UNITED STATES PATENT AND TRADEMARK OFFICE

APPLICATION NO.	FILING DATE	FIRST NAMED INVENTOR	ATTORNEY DOCKET NO.	CONFIRMATION NO.
10/542,961	07/21/2005	Christopher Neil Wood	038665.56621US	2045
23911 7590 05/03/2007 CROWELL & MORING LLP INTELLECTUAL PROPERTY GROUP P.O. BOX 14300 WASHINGTON, DC 20044-4300			EXAMINER AMIRI, NAHID	
			ART UNIT 3679	PAPER NUMBER
			MAIL DATE 05/03/2007	DELIVERY MODE PAPER

Office Action Summary	Application No.	Applicant(s)	
	10/542,961	WOOD ET AL.	
	Examiner	Art Unit	
	Nahid Amiri	3679

DETAILED ACTION

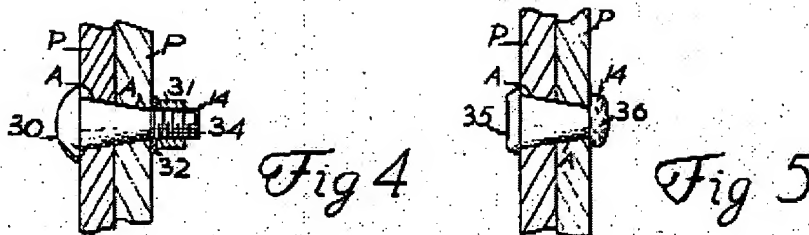
Claims 1-3, 6, and 10 are rejected under 35 U.S.C. 102(b) as being anticipated by US Patent No. 3,369,440 King, Jr.

With respect to claim 1, King, Jr. discloses an assembly (Figs. 4-5) comprising a fastener (30), a panel (P) and a supporting structure (P) to which the panel (P) is detachably fastened by the fastener (30), the panel (P) and supporting structure (P) being formed with tapered holes (A) which receive the fastener (30), the taper of one hole (A) being a continuation of the taper (A) of the other, and the fastener (30) urging a tapered surface into the tapered holes (A) in a non-jamming manner thereby locating the panel (P) with respect to the supporting structure (P).

With respect to claims 2, 3, and 6, respectively, King, Jr. discloses (Figs. 4-5) that the fastener (30) is positioned in the holes so as not to project beyond an external surface of the panel (P); wherein the tapered surface is formed on the fastener (30) itself; and wherein the angle of taper of the holes (A) and the angle of taper of the said tapered surface are the same.

With respect to claim 10, King, Jr. discloses a fastener (Figs. 4-5) for fastening a detachable panel (P) to a supporting structure (P), the panel (P) and supporting structure (P) being formed with tapered holes (A) which receive the fastener (30), the taper of one hole (A) being a continuation of the taper (A) in the other, the fastener (30) comprising a body having a tapered outer surface which is arranged to locate in the tapered holes (A) in a non-jamming manner and thereby position the panel (P) with respect to the supporting structure (P).

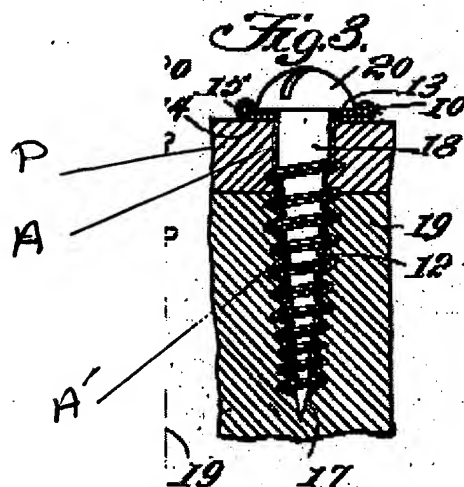
Claims 1-4, 6, 10, and 12 are rejected under 35 U.S.C. 102(b) as being anticipated by US Patent No. 2,666,354 Dim et al.

With respect to claim 1, Dim et al. disclose an assembly (Fig. 3) comprising a fastener (18), a panel (P) and a supporting structure (19) to which the panel (P) is detachably fastened by the fastener (19), the panel (P) and supporting structure (19) being formed with tapered holes (A, A') which receive the fastener (18), the taper of one hole (A) being a continuation of the taper (A') of the other, and the fastener (18) urging a tapered surface into the tapered holes (A, A') in a non-jamming manner thereby locating the panel (P) with respect to the supporting structure (19).

With respect to claims 2, 3, 4, and 6, respectively, Dim et al. disclose (Fig. 3) that the tapered surface is formed on the fastener (18) itself; wherein the tapered surface is formed on an element (12) located in the tapered holes (A, A'), and the fastener (18) passing through the element (12) to hold the element (12) in place; wherein the angle of taper of the holes (A, A') and the angle of taper of the said tapered surface are the same.

With respect to claim 10, Dim et al. disclose a fastener (Fig. 3) for fastening a detachable panel (P) to a supporting structure (19), the panel (P) and supporting structure (19) being formed with tapered holes (A, A') which receive the fastener (18), the taper of one hole (A) being a continuation of the taper (A') in the other, the fastener (18) comprising a body having a tapered outer surface which is arranged to locate in the tapered holes (A, A') in a non-jamming manner and thereby position the panel (P) with respect to the supporting structure (19).

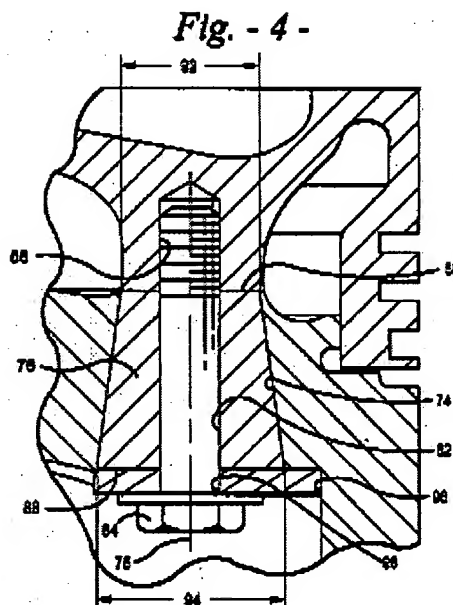
With respect to claim 12, Dim et al. disclose a fastener means (Fig. 3) for fastening a detachable panel (P) to a supporting structure (19), the fastening means comprising a tapered element (12) and a fastener (18), the panel (P) and supporting structure (19) being formed with tapered holes (A, A') which receive the tapered element (12) and the fastener (18), the taper of one hole (A) being a continuation of the taper in the other (A'), the tapered element (12) comprising a body having a tapered outer surface and having bore through which the fastener (18) can be passed to secure the tapered element (12) in the tapered holes (A, A') and thereby position the panel (P) with respect to the supporting structure (19).
